SP13-44 LIGHT SWITCH IN BAGGAGE COMPARTMENT  
REFER TO SAP FOR CODES AND VEHICLES  
VEUILLEZ VOUS RÉFÉRER AU RETROFIT R13056 POUR LA VERSION FRANCAISE

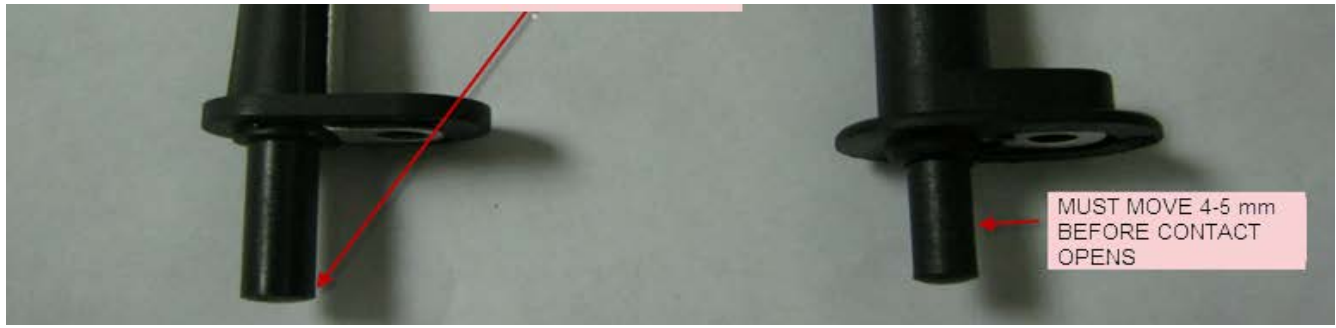
LIGHT SWITCH MAY OPERATE INCORRECTLY WHEN DOORS ARE CLOSED.

LIGHTS REMAIN "ON" INDEFINITELY.

ALL X SERIES VEHICLES WITH ALUMINUM DOORS ARE INCLUDED.

IN THE BAGGAGE COMPARTMENTS CHANGE ALL 563424 SWITCHES BY 562303 (6 TOTAL), EXCEPT FOR THE WCL DOOR (ALREADY HAS THE NEW SWITCH).

CHECK PROPER OPERATION AFTER REPLACING THE SWITCHES

MUST MOVE 4-5 mm  
BEFORE CONTACT  
OPENS
